March 9, 2021

Agenda Item #21 - Murphy Rd Subdivision 3-B-21-UR / 3-SA-21-C

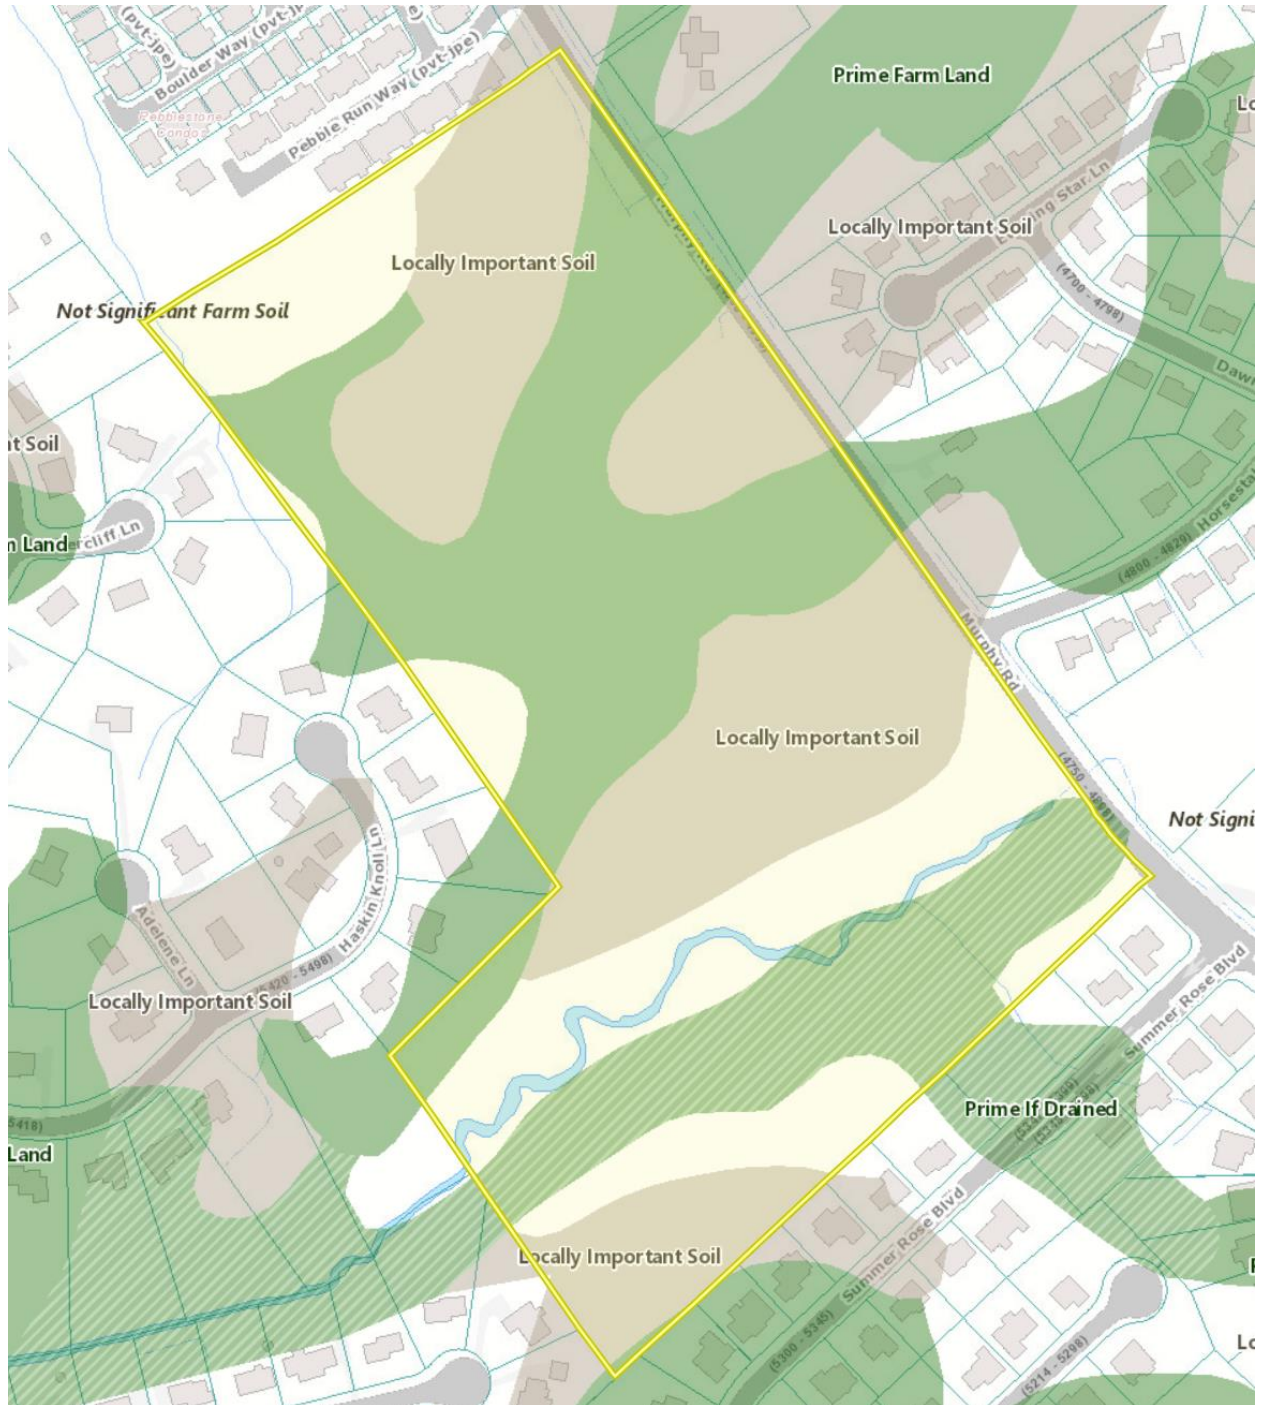
1. Sidewalks - could sidewalks be added - within the subdivision, and along Murphy Rd? Residents in the subdivision will interact significantly with the 500+ houses adjacent in Summer Rose and Shannon Valley Farms. There may also be residents who walk to neighboring Nature's Way Montessori School, and sidewalks are an important safety measure for those children, and for reducing overall vehicle traffic in our area. I understand some areas of the Murphy Road frontage may have constraints regarding guard rails and other features that make sidewalk installation difficult. The county should work with the applicant to overcome these constraints on the Murphy Rd frontage.

2. I understand there will be a pedestrian crossing at Murphy Rd to connect the east and west sides. This should be equipped with a warning light system – either signs, or perhaps in-roadway warning lights since typical speeds are 45mph or greater.

3. Intersection improvements at the proposed subdivision entrance / Murphy Rd / Horsestall Lane are needed. There are already collisions at that location. At a minimum, left turn lanes should be installed on Murphy Rd for both the new subdivision, and Horsestall Ln. **An attractive alternative is a roundabout**, which would also slow traffic in the area, and increase pedestrian safety.

4. There should be a landscaping screen along Murphy Rd. Many of those houses will have backyards that open up into a road with about 8,000 vehicles a day. It would provide those houses privacy if there was a landscaping screen, similar to the landscaping screen on Shannon Valley Farms across the street.

5. Questions about future development areas on the western portion of the parcel that are not included in this concept plan. Will this be recreational open space, agricultural fields, and/or walking trails (which would be especially nice along White's Creek). Should the concept plan go ahead and include that in the proposal now,?

6. Is there a way to utilize conservation subdivision techniques to preserve some of the prime farmland soils on the property and cluster houses on the area with less valuable soil?
